**Re: Response to Comments Letter
McDonald's Restaurant
413 Main Street
Reading, MA**

Please find below our responses to Planning Division comments provided via email from Mary Benedetto, Senior Planner, on August 23, 2023 and a Memo provided by the Town of Reading Engineering Division dated August 31, 2023. For clarity, the comments are in italics, while our responses are directly below in normal font. This response letter references plans by Bohler Engineering revised through 8/15/2023.

Planning Division comments via email dated August 23rd, 2023

PLAN APPROVALS	DATE	APPROVED MCDONALD'S AGENT
SIGNATURE		
STATUS	DATE	BY
DRAWN BY:	04/28/2023	CSE
PLAN CHECKED	-	-
AS-BUILT		
SHEET No.	C-501	
	OF 15

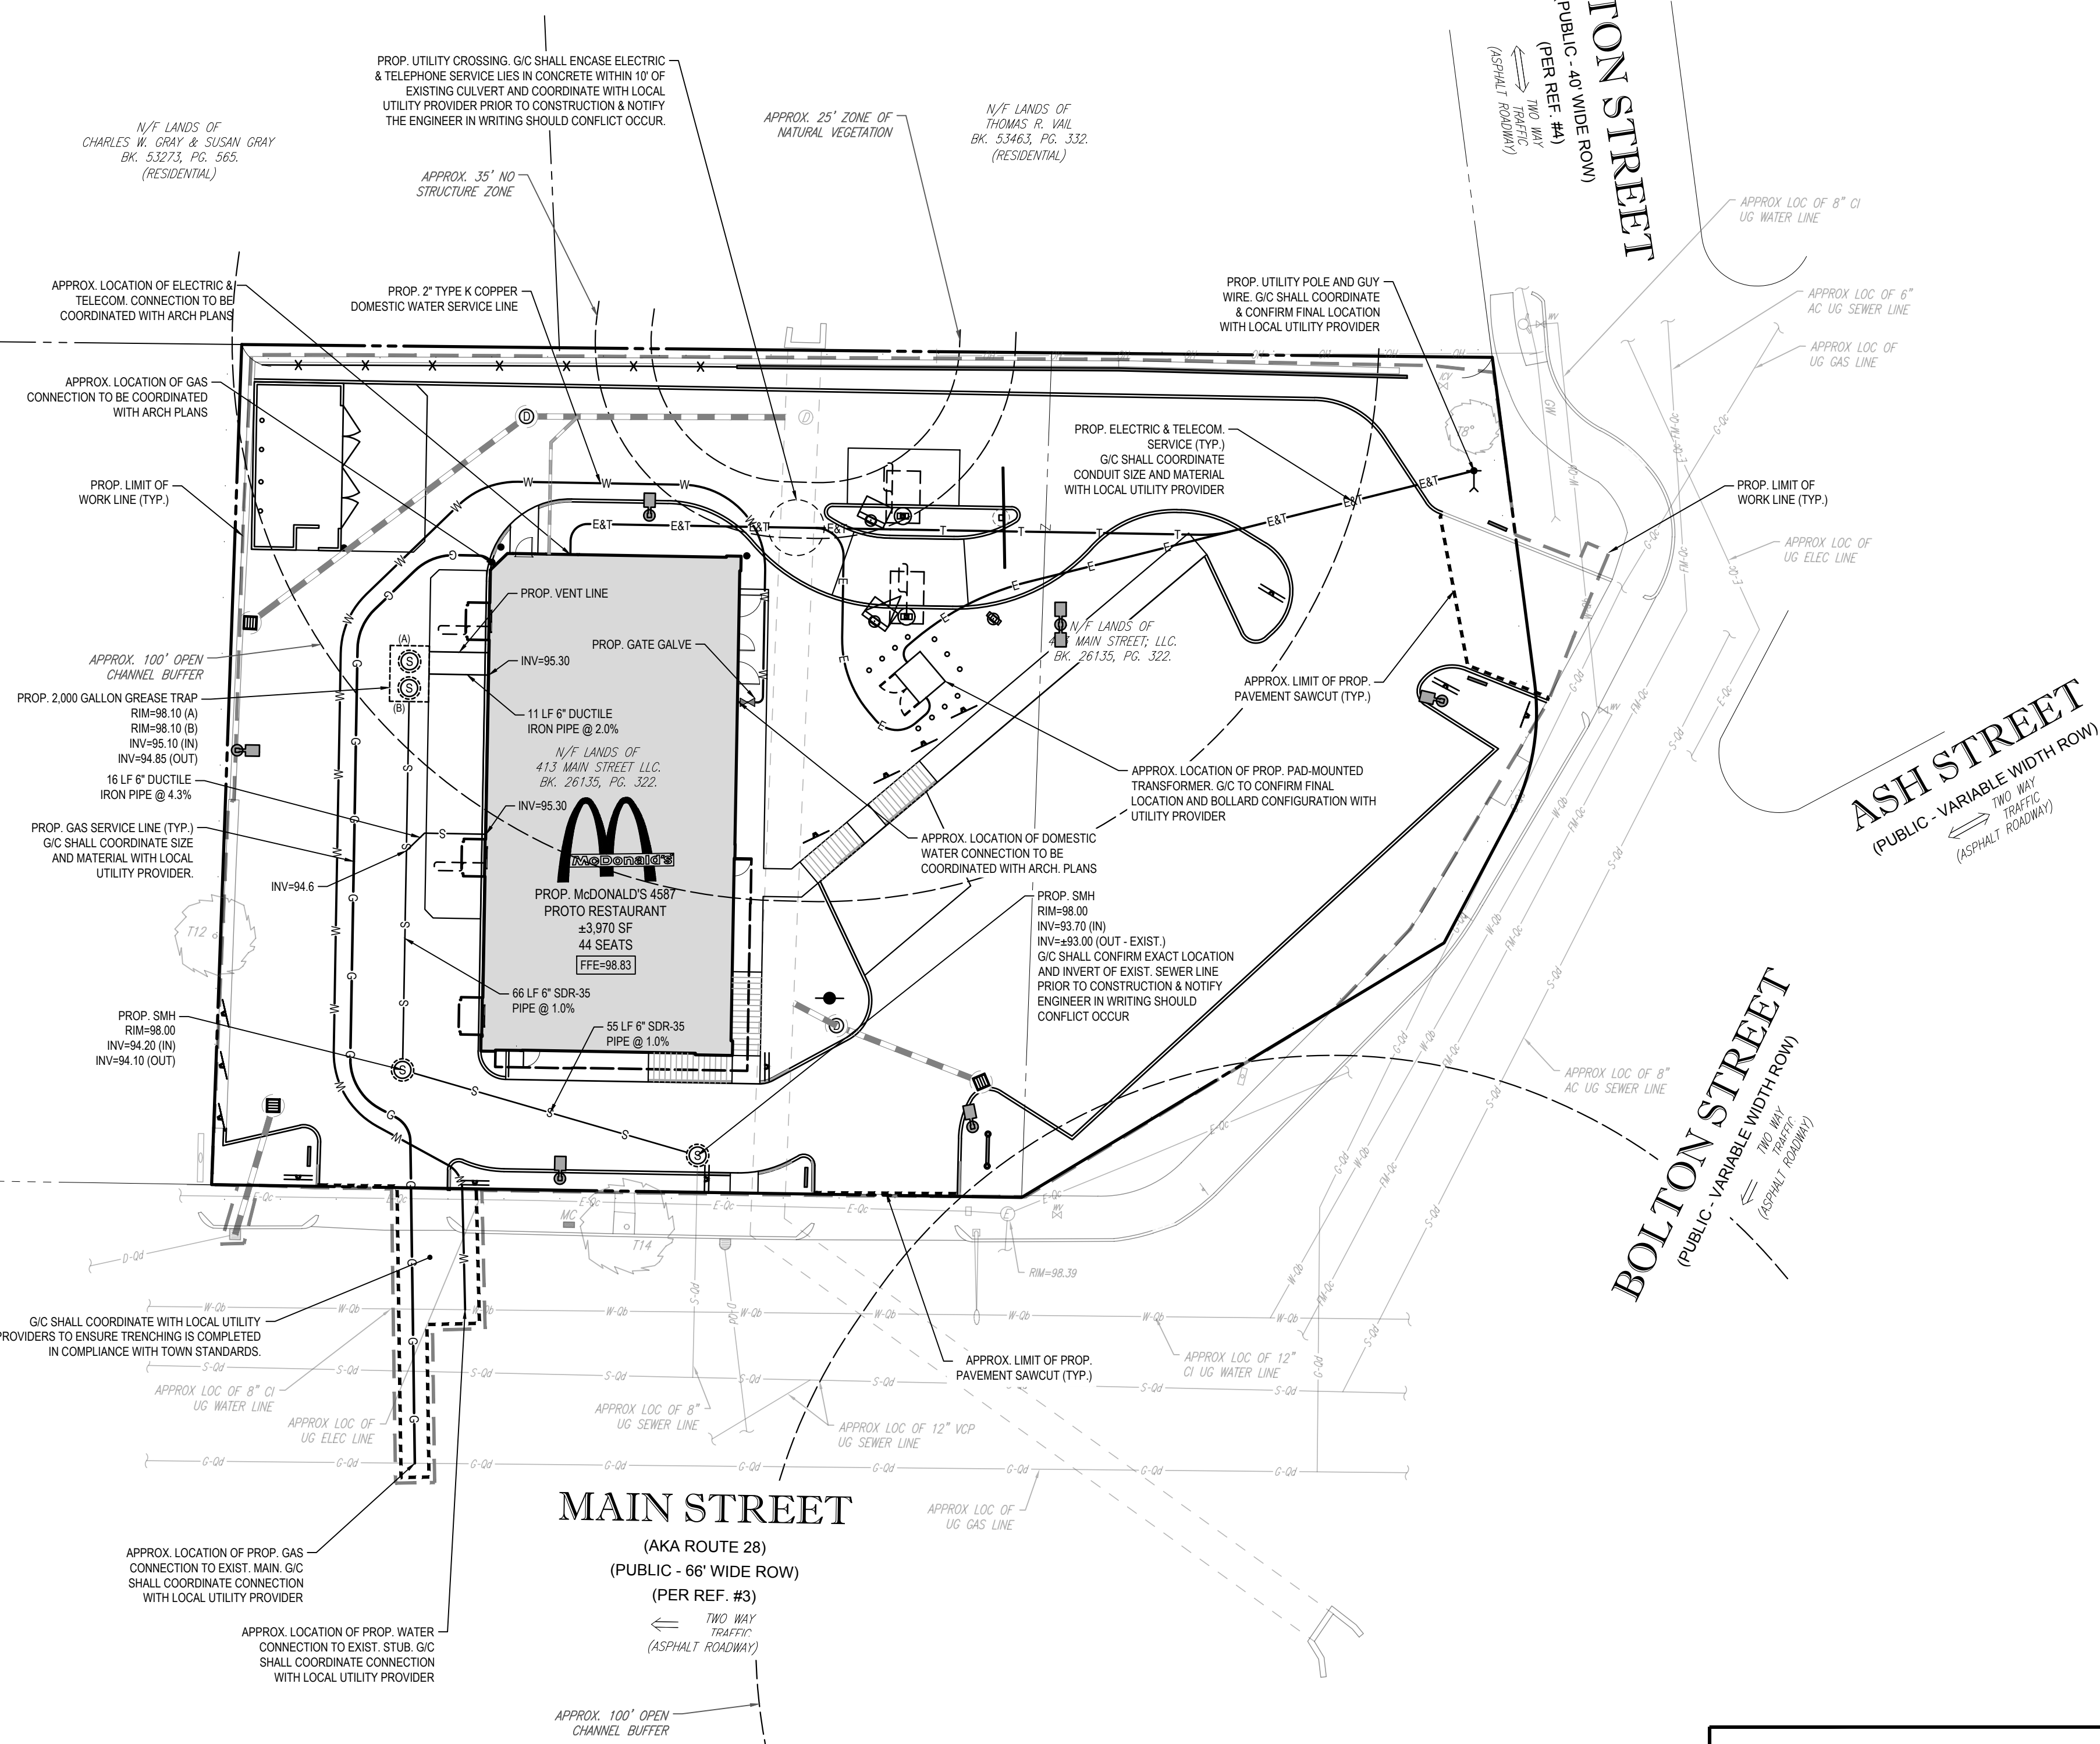
Comment 12: *Trench paving in the Town ROW shall meet Town Standards for this area.*

Response 12: Comment acknowledged. Plans have been revised to specify trenching within ROW shall meet Town standard as seen on the Plan sheets C-301 and C-501.

SHEET 1

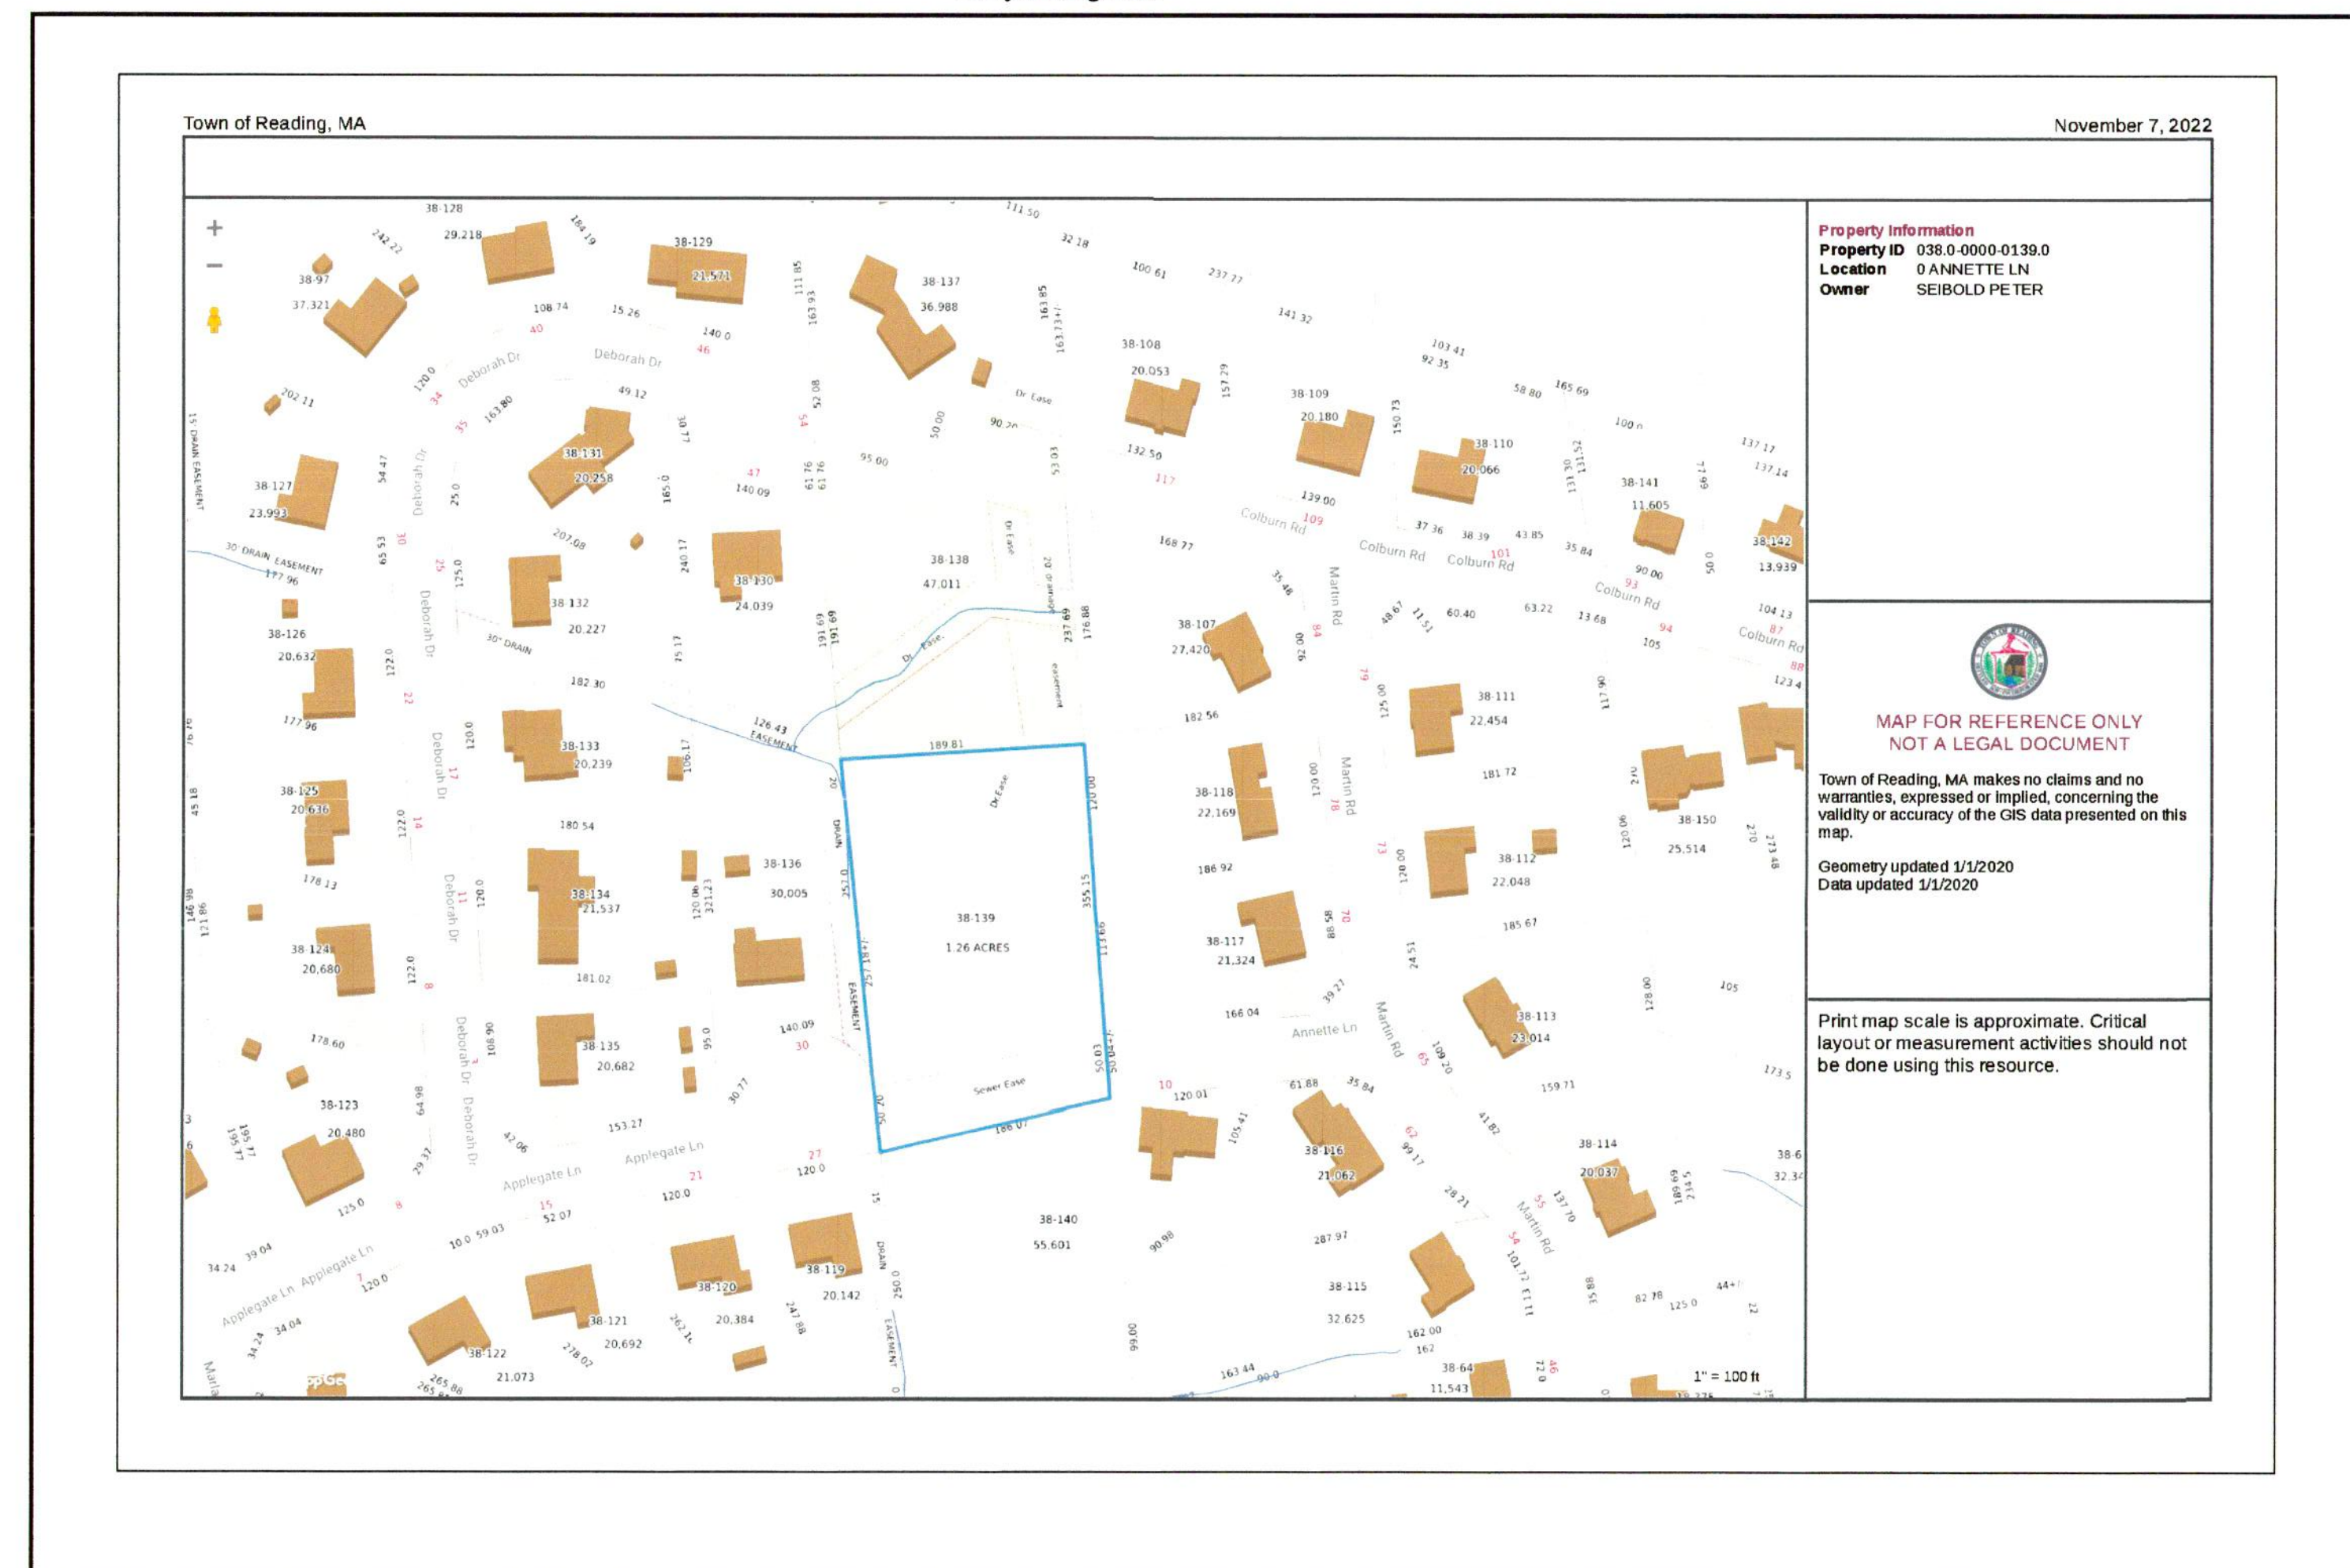
6. *Please revise the title on the current Sheet 3 from "Definitive Subdivision Plan" to "Approved Preliminary Plan" or something like that. Engineering noted that plan was slightly different the later sheets done by Somerville Engineering and retitling it would clear this up for anyone reviewing it that isn't aware of the full background of the Preliminary Plan.*

The title of Sheet 3 has been changed from "Definitive Subdivision Plan" to "Approved Preliminary Plan". A stamped copy of the revised plan is attached to this letter.
